PREPARED FOR THE PLAN COMMISSION

Project Address: 2583 University Avenue (5th Aldermanic District, Alder Bidar-Sielaff)
Application Type: Conditional Use
Legistar File ID #: [36814](#)
Prepared By: Heather Stouder, AICP, Planning Division
Report Includes Comments from other City Agencies, as noted

Requested Action: Approval of a conditional use for construction of a 27-unit multi-family residential building over 10,000 square feet in size and over 40 feet in height in the Traditional Shopping Street (TSS) District.

SITE PLAN
C-1.1 1" = 10'-0"

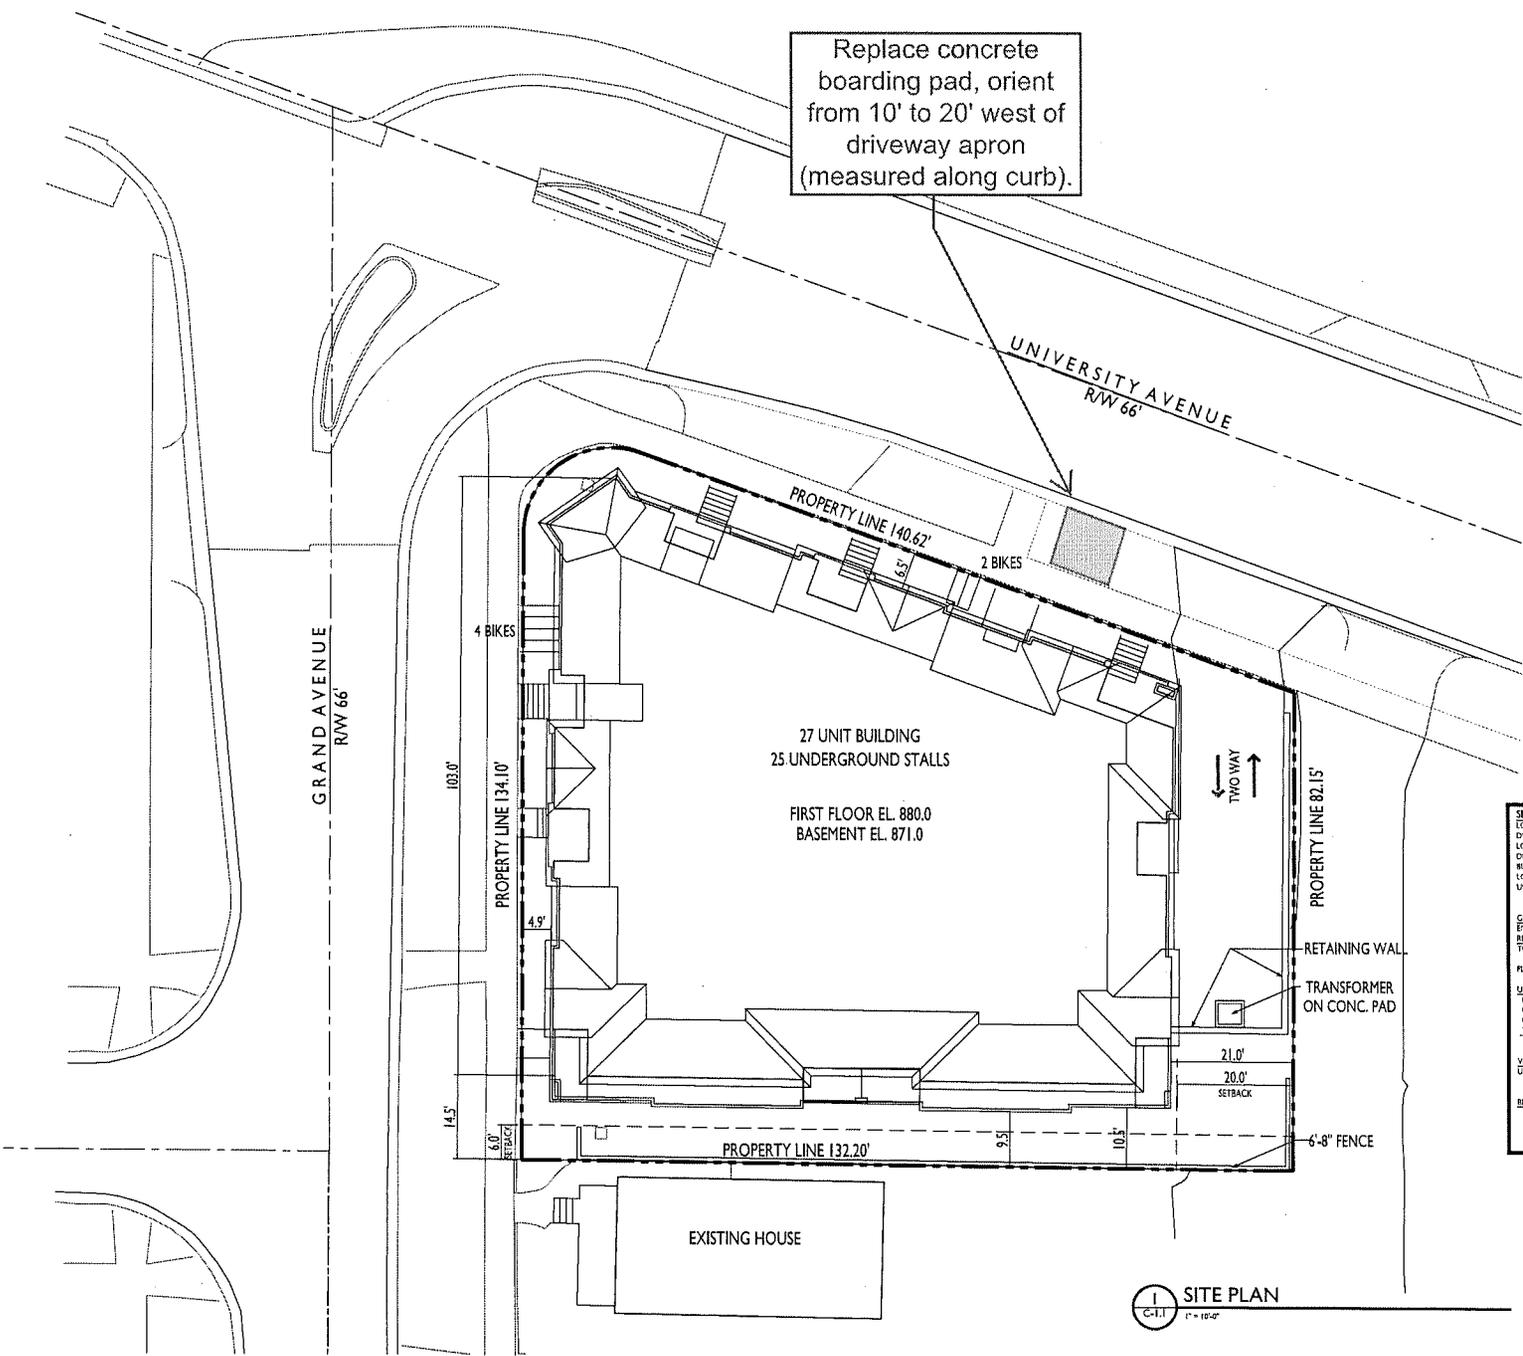
45. In coordination with public works improvements, the applicant shall replace the concrete passenger boarding pad at the existing Metro bus stop on the south side of University Avenue, east of Grand Avenue (#2433). The concrete pad shall occupy the full distance of the terrace, measure a minimum of 10 feet in width parallel to the street, and lie flush between the sidewalk and the top of curb. The replacement concrete pad shall be oriented to span from ten feet to twenty feet west of the new (narrowed) driveway apron.

Replace concrete boarding pad, orient from 10' to 20' west of driveway apron (measured along curb).
